Wisconsin Department of Transportation

Proposal #30: 9304-11-70, WISC 2021 097
Armstrong Creek - Florence
West Oneonta Ln – Woods Creek Rd
STH 101
Florence County

9304-12-70, WISC 2021 098
Armstrong Creek - Florence
USH 8 – West Oneonta Lane
STH 101
Forest County

This is Addendum No. 03, which provides for the following:

DETAIL FOR CURB AND GUTTER REMOVAL/REPLACEMENT

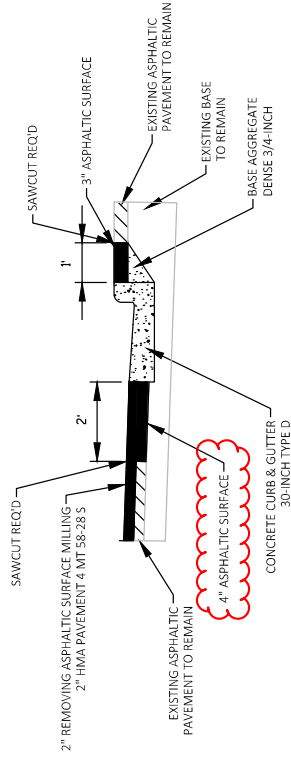
Revised Plan Sheets	
Plan Sheet	Plan Sheet Title (brief description of changes to sheet)
6	Construction Details (changed the bid item label “ 4” HMA Pavement 4 MT 58-28 S “ to “ 4” Asphaltic Surface ” for the curb and gutter replacement asphaltic patching).
19	Misc. Quantities (the quantity of the bid items HMA 4 MT and Asphaltic Surface was revised to reflect the item change used to patch the curb and gutter replacement locations. The Note at bottom the HMA table was revised to reflect these this change as well. The quantity for bid item 460.0105.S HMA PWL Test Strip Volumetrics was changed to match the quantity in the estimate. The Density Acceptance item shown in the PWL table for the sideroad intersections was changed from “Acceptance Testing by the Department; Not Eligible for Incentive” to “Incentive Density HMA Pavement 460.2000” to match the correct bid item in contract estimate.)
